TECHNICAL BULLETIN

MODEL/DERIVATIVE:
Discovery II

Bulletin N°: 0086
CDS. ref: L8685bu
Issue: 1
Date: 19.12.01

PROBLEM:
KNOCKING / CREAKING NOISE FROM THE FRONT OF THE VEHICLE
Knocking / creaking noise when turning at slow speeds (predominantly steering from lock to lock).

Right hand drive vehicle (Arrow points towards front of vehicle)

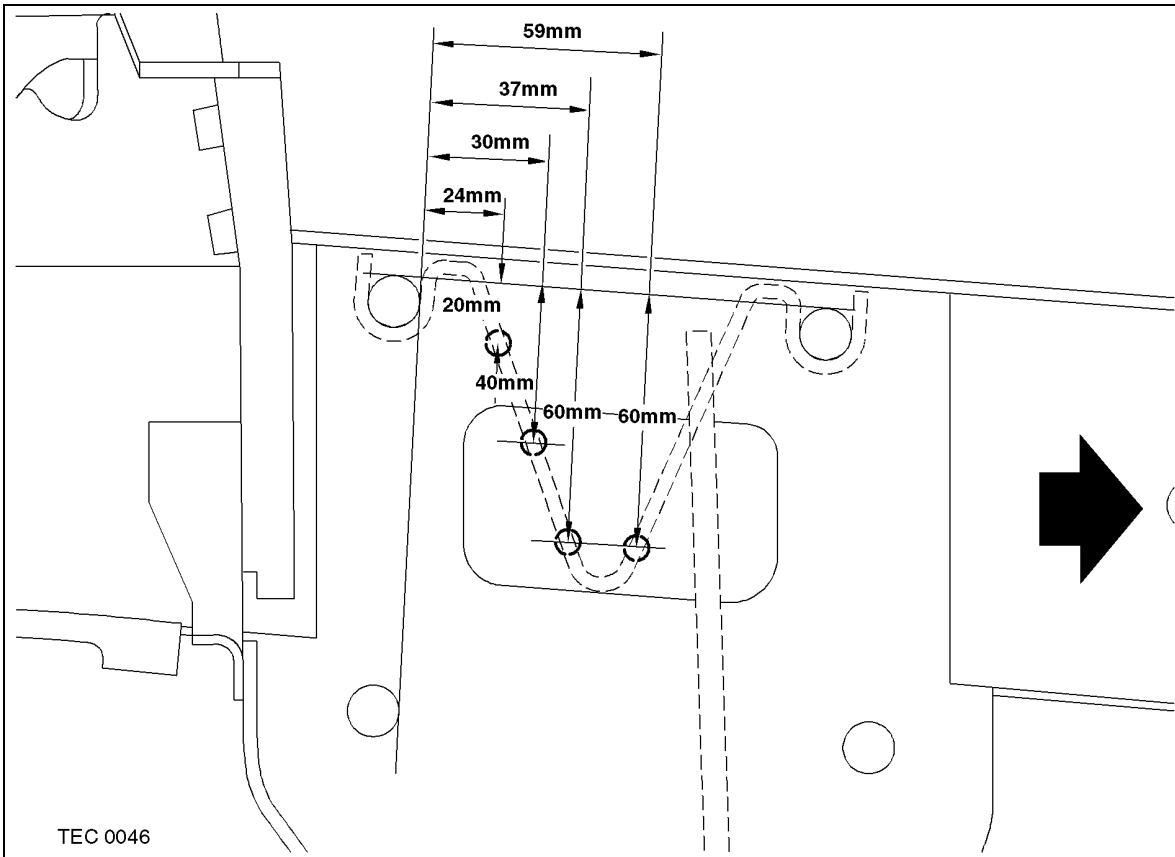
CAUSE:
Movement of internal spacer in the front longitudinal chassis member where the Power Assisted Steering (PAS) box is located.

ACTION:
Where a complaint of the above is confirmed, locate and plug weld the spacer as described below.

7. Flat bottom drill 4 holes 8 mm diameter at the positions marked, drill until internal spacer is exposed, the holes can be drilled to a maximum of 10 mm. Depth of the holes may vary.
CAUTION: If the spacer is not exposed, a further hole may have to be drilled to establish the position of the internal spacer.
8. Grind chassis to expose bare metal around the drilled holes.

9. MIG weld the edge of the internal spacer to the chassis, ensure spacer is fixed to the chassis before proceeding. Completely fill all holes with weld.
10. Grind excess weld material level with the chassis.
11. Etch prime bare metal, repair paint finish as required.
12. Refit steering box bolts and tighten to 90 Nm.
13. Refit anti-roll bar link, washer and nuts and tighten to 100 Nm.
14. Lower vehicle.
15. Refit the front road wheel on the drivers side and tighten nuts to 140 Nm.
16. Reconnect the alternator and the battery earth leads.
